DRB CASE ACTION LOG

EPC Application No.: 03EPC-00487_00488, 00489 Project Name: MRGCD MAP 32 Phone No.: 897-0010 Agent: Community Sciences Corp. Your request for (SDP for SUB), (SDP for BP), (FINAL PLATS), (MASTER DEVELOP. PLAN), was approved on 1/25 Oby the DRB with delegation of signature(s) to the following departments.

Project # 1002562

5018 SECOND STREET NW PLAN FOR SU C-1 ZONING AND SU1 C-1 WITH CONTRACTOR'S YARD

PROPOSED SITE PLAN AND CONDITIONS

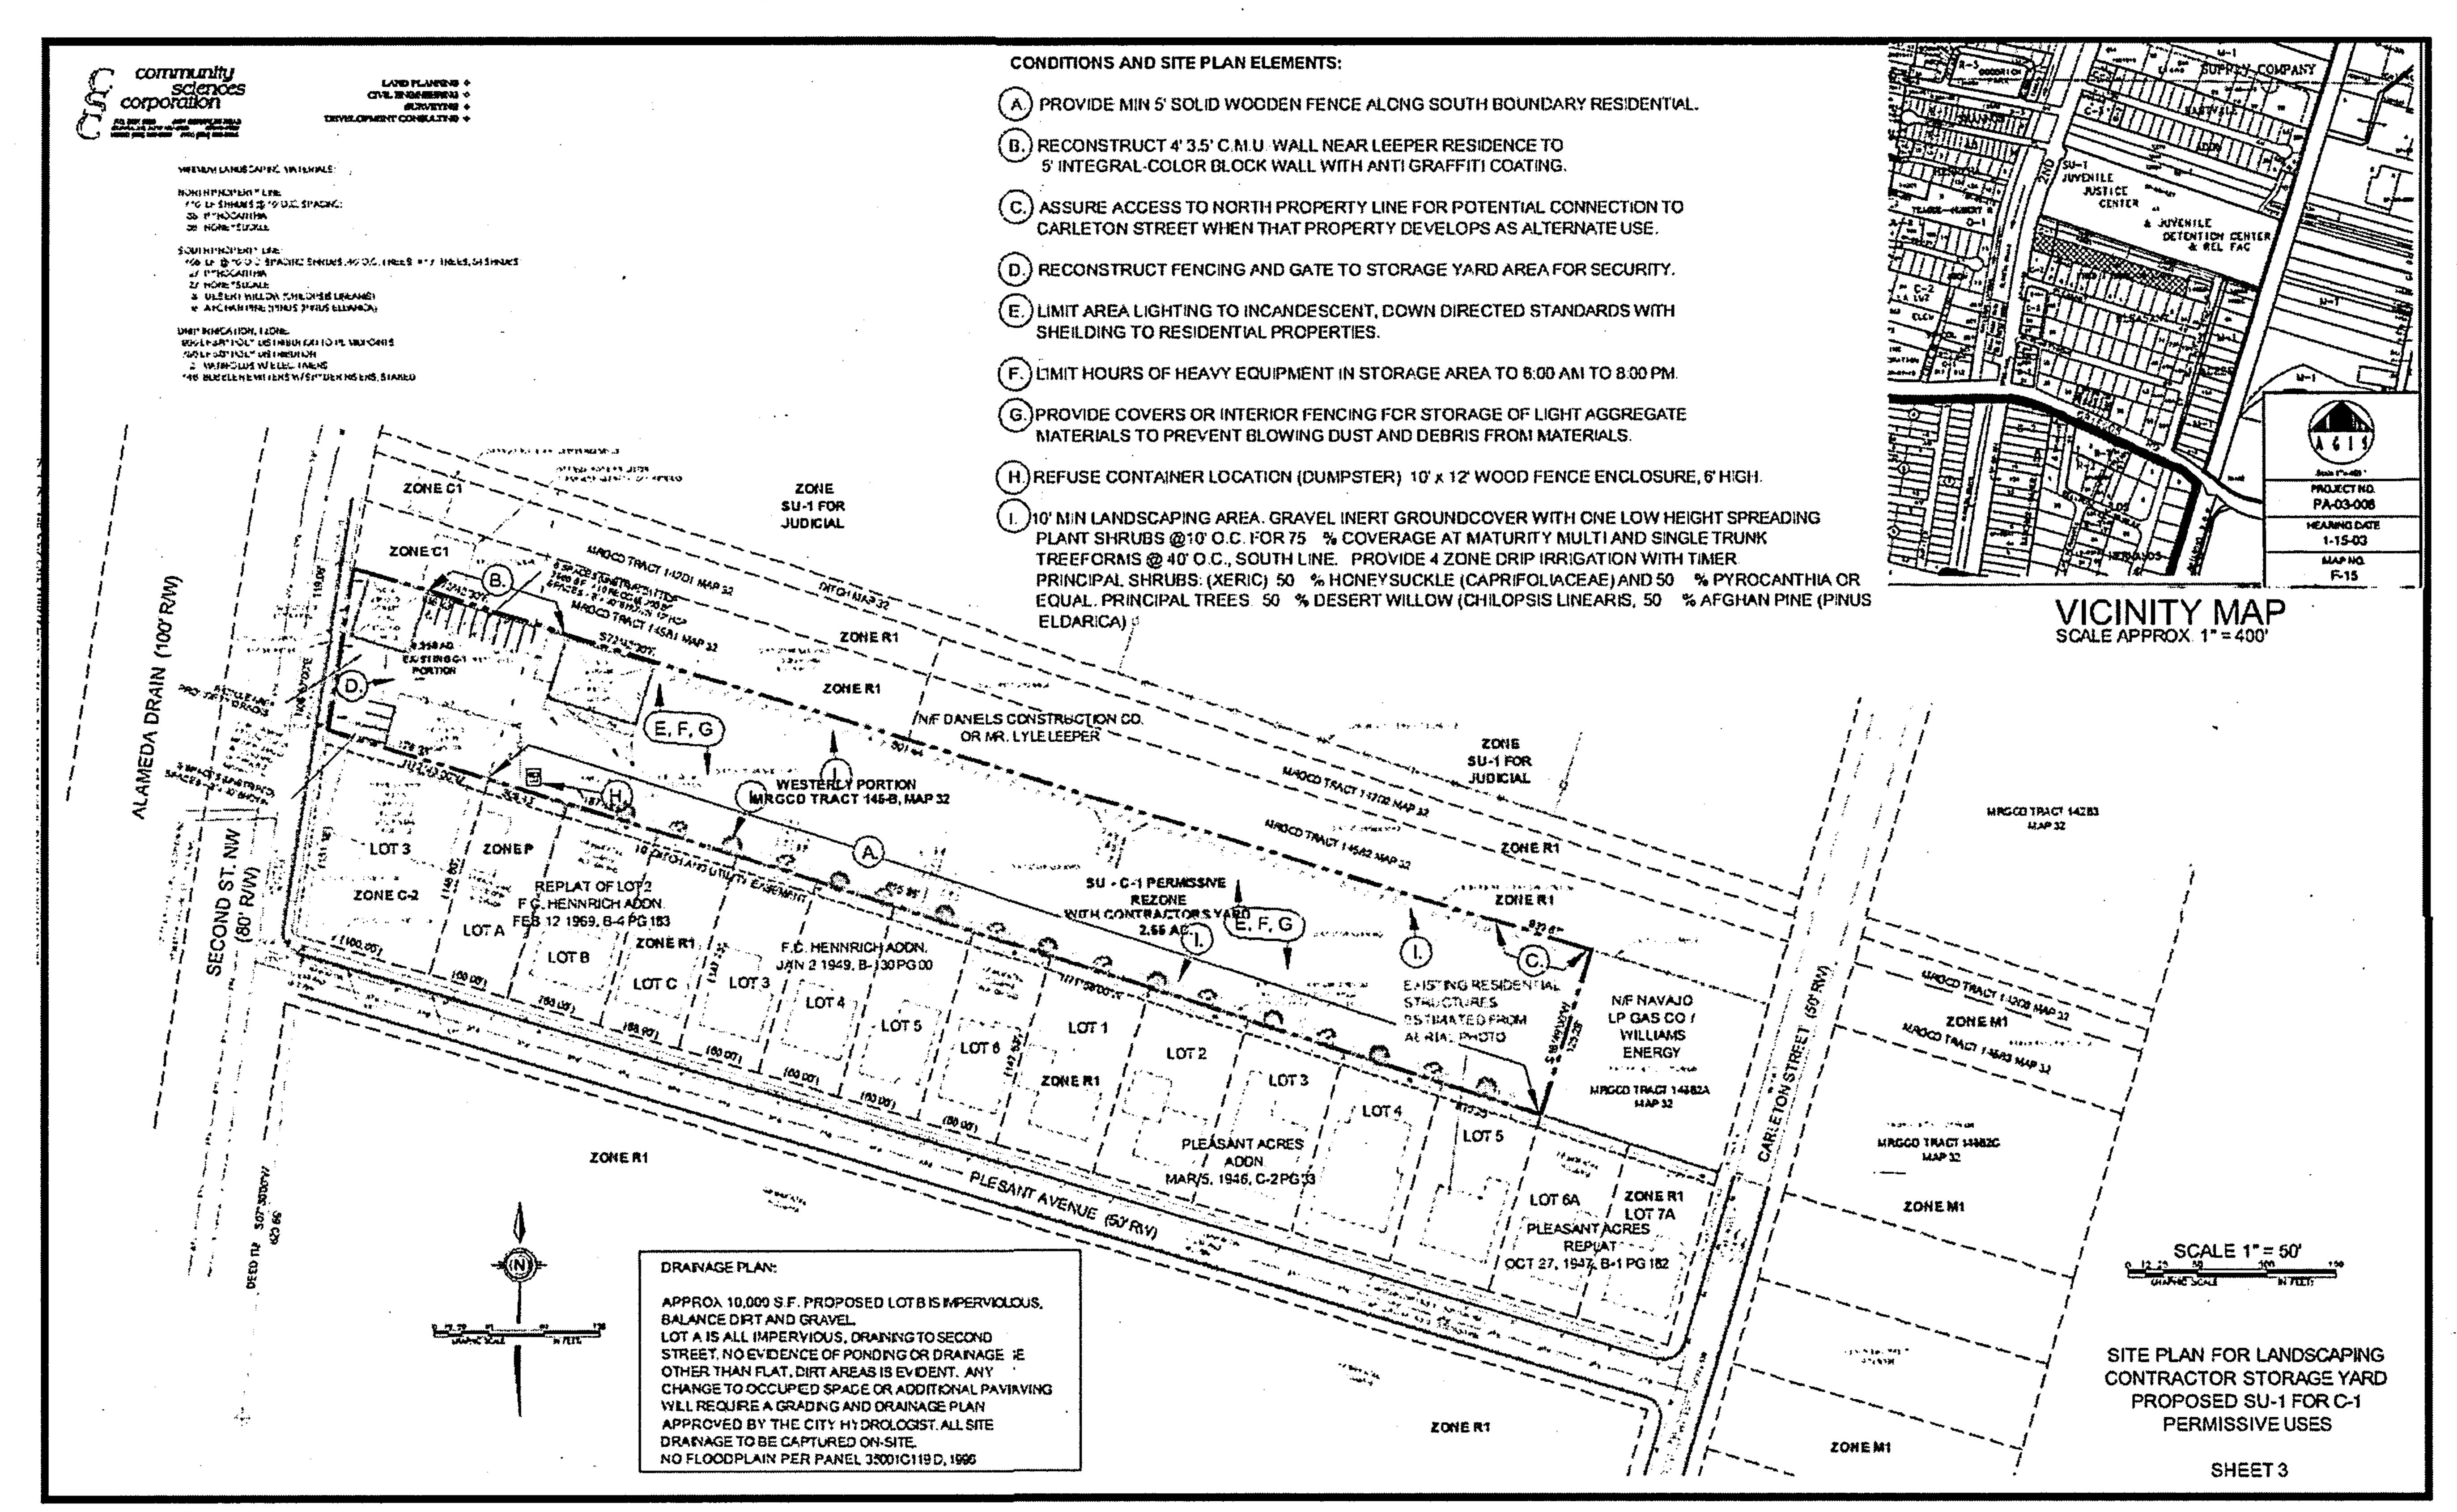
Off-Street Parking does not specify the type of paving.

2. All off-street parking is required to be paved parking.

All off-street parking is required to be striped.— Remove Site Flan Luns haped

The applicant does not provide an illustration of the bike rack.

5. Number of bicycle spaces is not specified.

1.) A-6' Landscape Buffer is required between the off-street parking spaces and the north property line as specified in Section 14-16-3-10(E)(3) of the Comprehensive

A 10' landscape buffer is required along 2nd St NW as specified in Section 14-16-3-10(E)(3).

Per the condition of approval, the applicant is required to install Street Trees along 2nd Street as regulated in the Street Tree Ordinance. This site is zoned SU-1 and EPC has utilized its authority to require additional landscaping.

The submittal does not contain landscaping calculations and a notation that 75%. of the area will be living ground cover.

5howing 5. The maintenance party must be specified on the submittal.

6. The submittal does not include dimensions of all the landscaped areas.

Under the "Landscaping" general notes, the third sentence needs to be removed. The applicant is required to provide large trees along the north property line.

- 2. All parking shown as on existing asphalt (existing conditions plat, EPC)
- 3. O.K. That's the purpose to stripe existing per sheet 1
- 4. Not required at EPC. No City Standard.
- 5. Notre, steet 1, shows "provide 2 racks" e.g. 2 bicycles.

- of Mr. Leeper's wall (Note B). Adding a 6' Landscape over was not on EPC set. Existing perement to wall exists, Mr. Leeper doesn't core. His premess adjacent is C1.
- 2. Not part of EPC action. Can't do (boildies within 7'd proporty line —all concrete walks and asphalt now.
- 3. Not part of EPC or Code. No building construction of this time!
- 4. See notes and irrigation materials, Sheet !
- 5. I added note
- 6. Yes they do. See call outs (10'min) and materials potes.
- 7. ? OK. Crossed out.

All of-street parking is required to be striped. Community Sciences Corporation has added a note on the Site Plan calling for striped parking.

The applicant does not provide an illustration of the bike rack. 宣 ⓒ 匡 [] I have added an illustration for the bike rack. JUL 0 2 2003 Number of bicycle spaces is not specified. The number of spaces for bike rack are shown on previous submittal. HYDROLOGY SECTION

The first 150' of the north property line, starting at the NW corner, is encumbered by preexisting conditions (asphalt and buildings). Proposed solution for this portion of the property is integral color block wall that is suggested on the Site Plan. After the initial 150 feet CSC has shown a 10' buffer along the remainder of the north property (on previous submittal).

- 5. The maintenance party must be specified on the submittal.
 Added note under landscaping that the property owner will be responsible.
- 6. The submittal does not include dimensions of all the landscaped areas. Added south 10' landscape buffer to revised Site Plan.
 - 7. <u>Under the "Landscaping" general notes, the third sentence needs to be removed. The applicant is required to provide large trees along the north property line.</u>
